## SUBDIVISION REVIEW SHEET

**CASE NO.:** C8-2022-0003.0A

**SUBDIVISION NAME:** 5600 Jackie Robinson

## CITY OF AUSTIN –DEVELOPMENT SERVICES DEPARTMENT SUBDIVISION APPLICATION – MASTER COMMENT REPORT

## Exhibit A: Vicinity Map

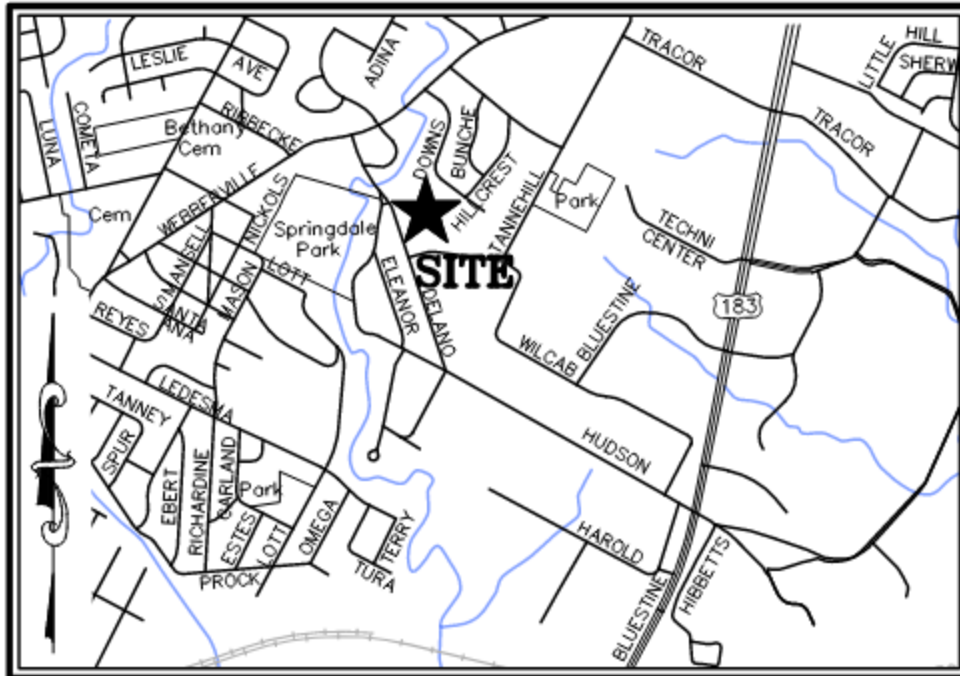
- AD1.** Please update the following labels in the vicinity map to include street types. Remove all other street names otherwise include street types for all the names shown in the vicinity map §25-4-155
- 1. **DELANO ST** the street type LN must be included
  - 2. **HILCREST LN** the street type LN must be included
  - 3. **DOWNSDR** the street type LN must be included
  - 4. **TANNEHILL LN** the street type LN must be included
  - 5. **WEBBERVILLE RD** the street type LN must be included
- AD2.** Please change the label for 183 so that **ED BLUESTEIN BLVD** appears above the label US 183. US 183 should be enclosed within parenthesis and not be bold. §25-4-155  
**ED BLUESTEIN BLVD**  
(US 183)

Exhibit B: Proposed Plat

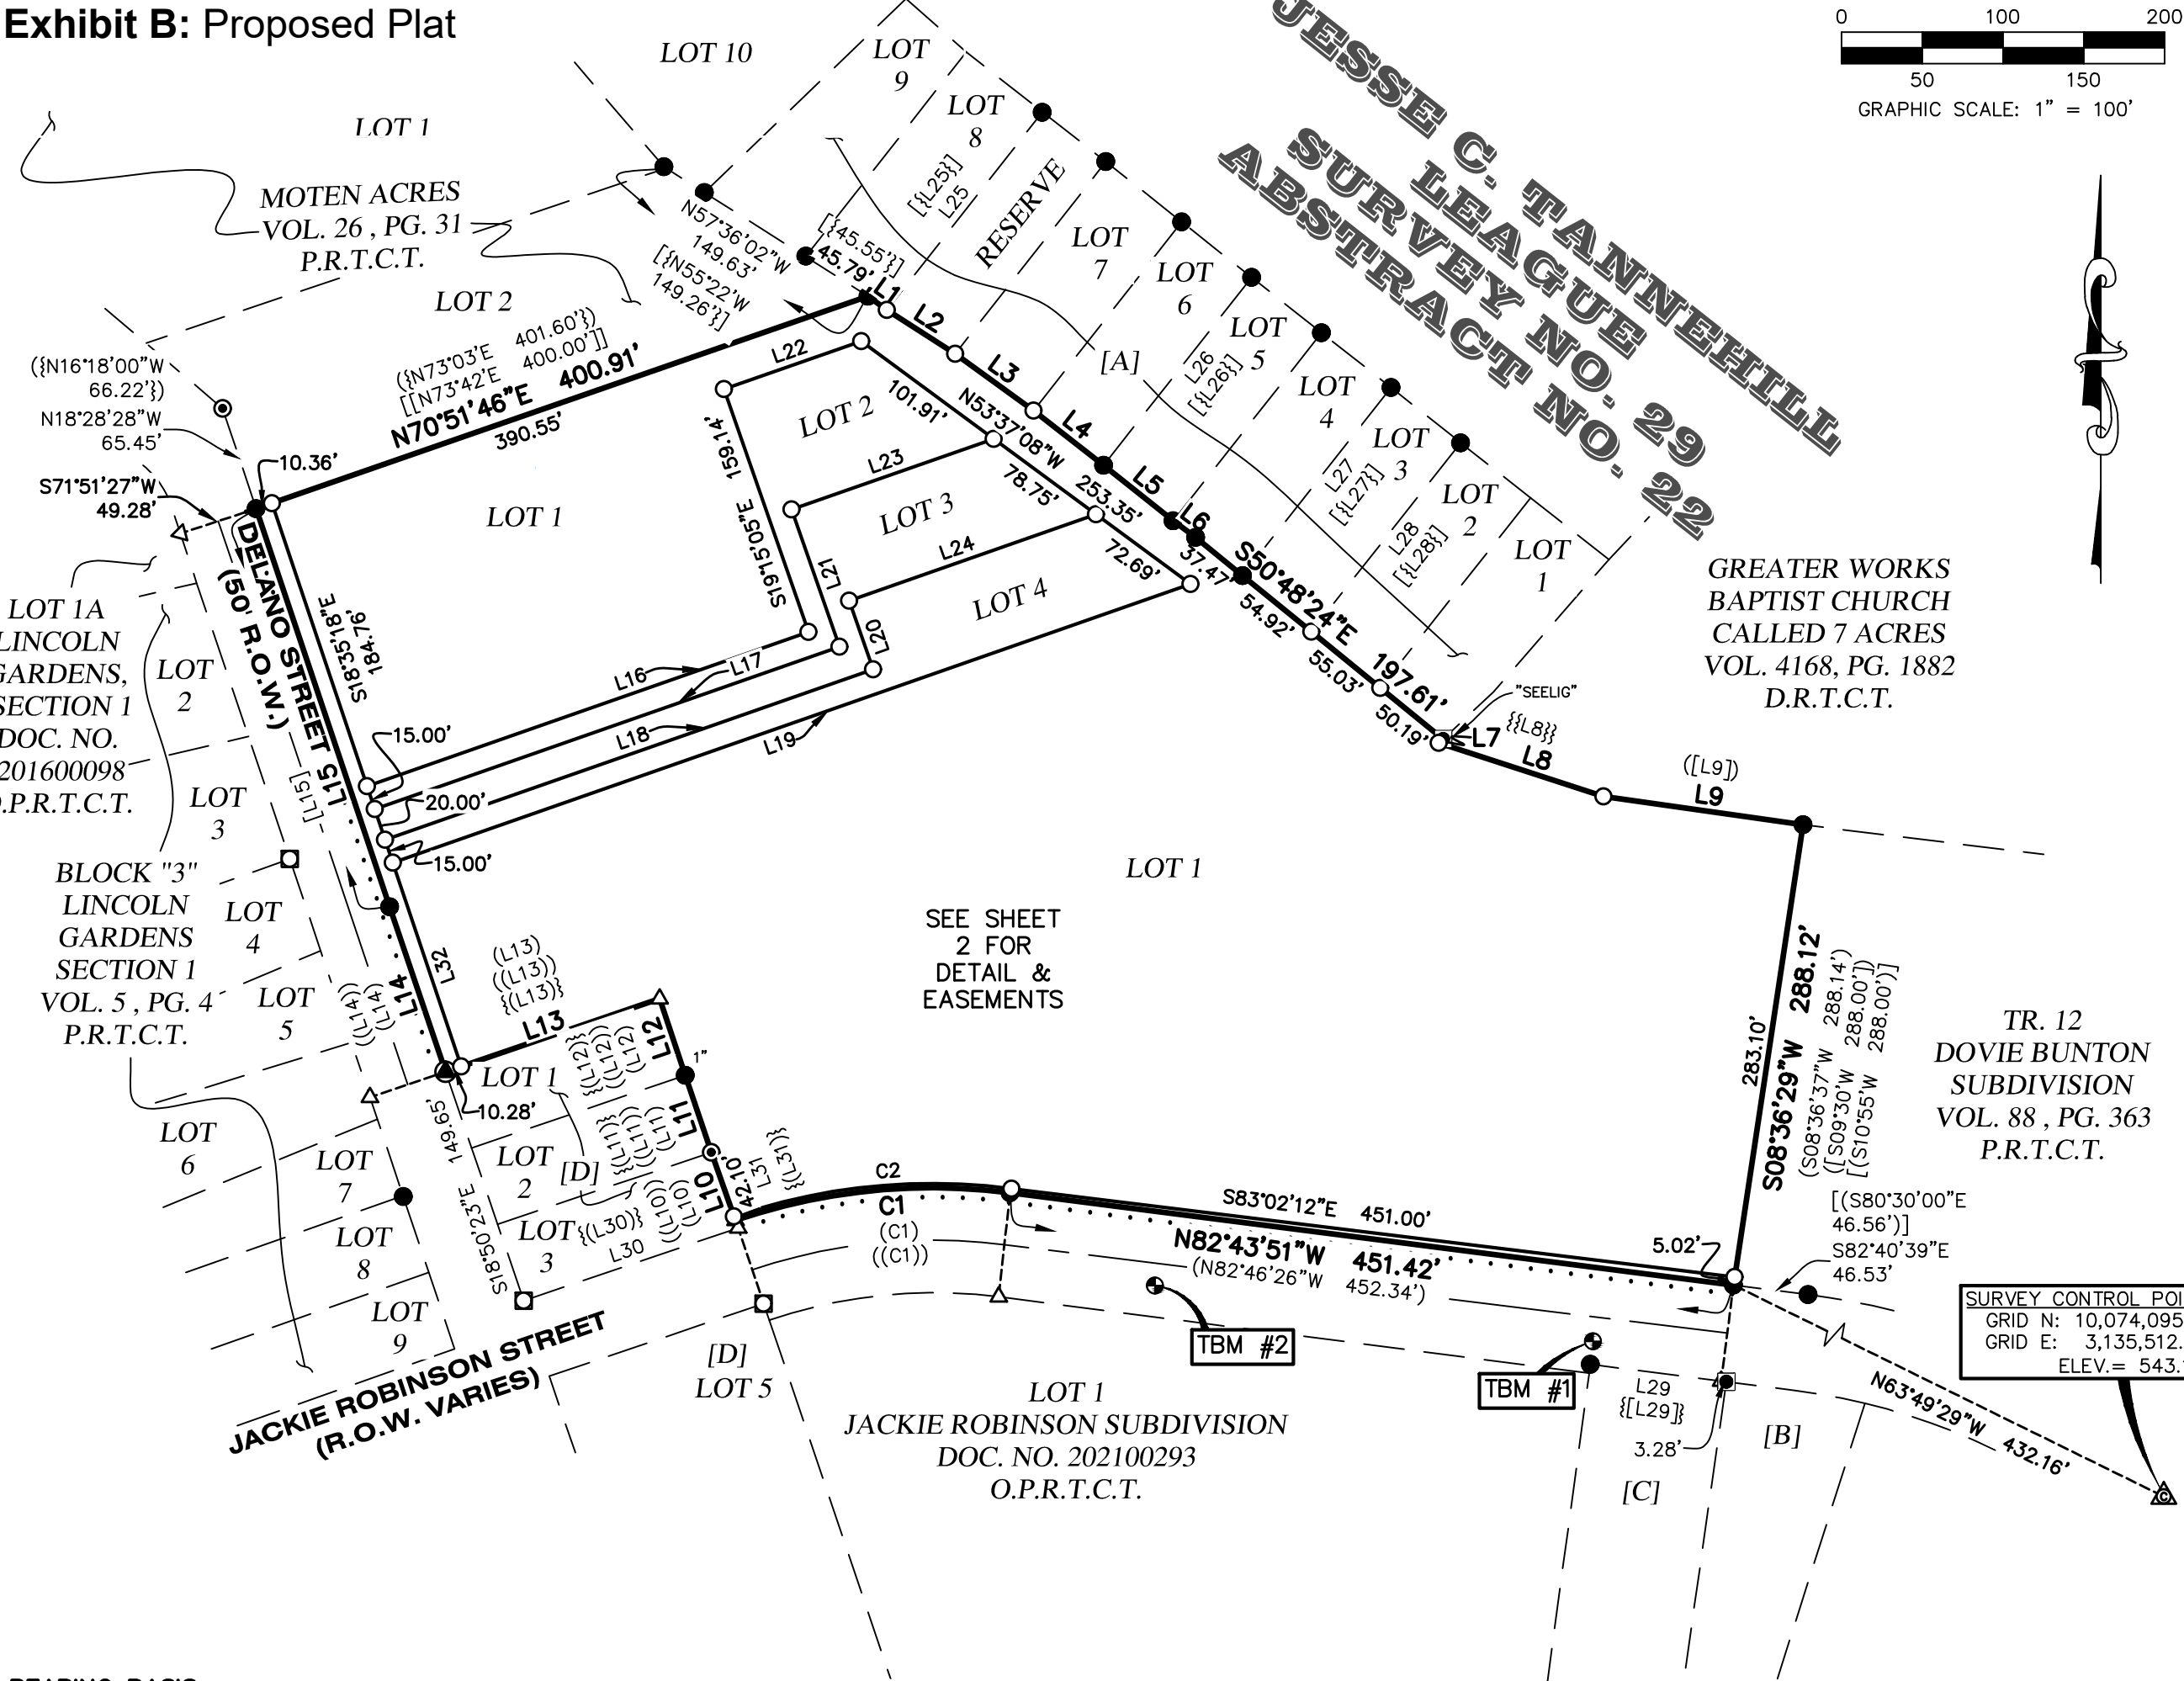
**SR5.** Please revise the following administrative approval block 25-1-83:

**SR6.** Please check the plat for typos grammatical errors for instance in the owner's dedication statement and remove any specific references to current city code such as in plat note 16 (25-1-83)

**SR7.** Please delete the building set back line from the legend and any building set back lines that appear on the face of the plat/ plat diagram. Ensure that Everything referenced in the legend appears on the plat and everything that appears on the plat appears in the legend. (25-1-83)

**SR8.** Modify the recordation block as shown: 25-1-83
